ATTACHMENT 2A TO AEP:NRC:0433Q

TECHNICAL SPECIFICATIONS PAGES
MARKED TO SHOW PROPOSED CHANGES

UNIT 1

REVISED PAGES

~~Figure 5.6-3: Acceptable Burnup Domain in Regions 2 & 3~~

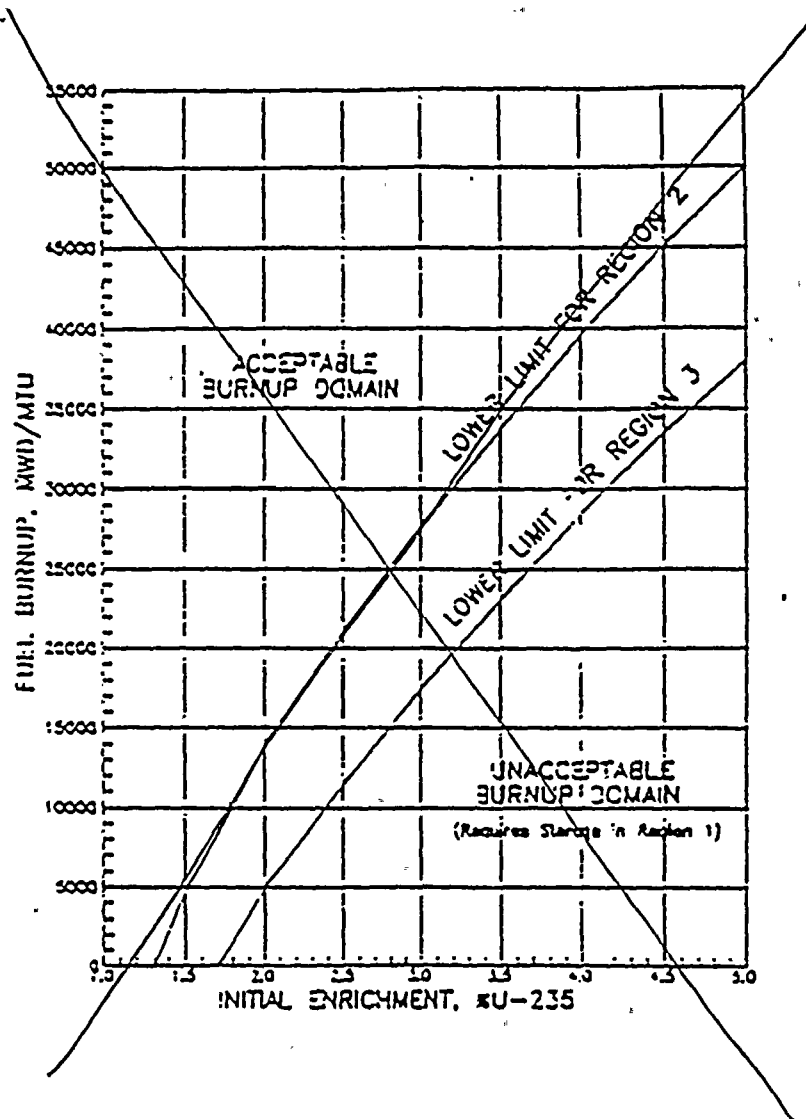
The equivalent reactivity criteria for Region 2 and Region 3 is defined via the following equations:
~~and graphically depicted in Figure 5.6-3.~~

Deleting the redundant figure for equivalent reactivity criteria for regions in the spent fuel storage racks does not impact the storage requirements because the equations provide equivalent requirements. The unlikely event of a fuel assembly being misloaded is independent of the characteristics of the spent fuel in the pool. It has no impact on the event initiator, which is a human error while positioning a fuel assembly. The change has no impact the assumptions for a fuel handling accident because the fuel storage requirements are not changed. The consequences of an accident are not increased because the fuel storage requirements are not changed and no other changes are made to systems that mitigate the consequences of an accident.

~~Figure 5.6-3: Acceptable Burnup Domain in Regions 2 & 3~~

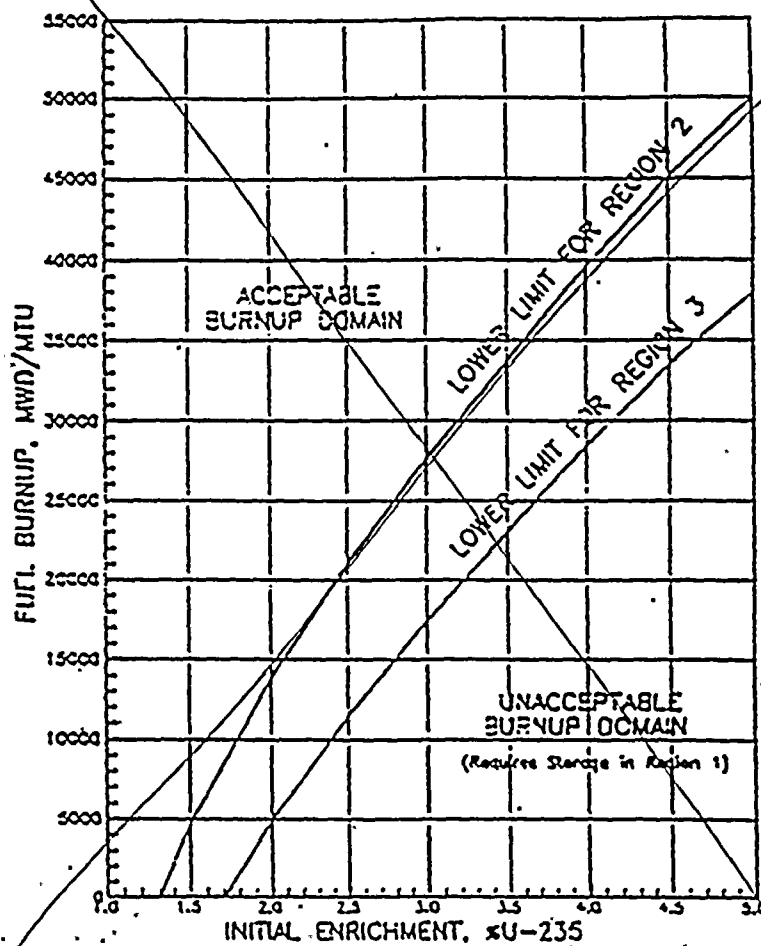
The equivalent reactivity criteria for Region 2 and Region 3 is defined via the following equations, ~~and graphically depicted in Figure 5.6-3.~~

Figure 5.6-3 intentionally deleted.
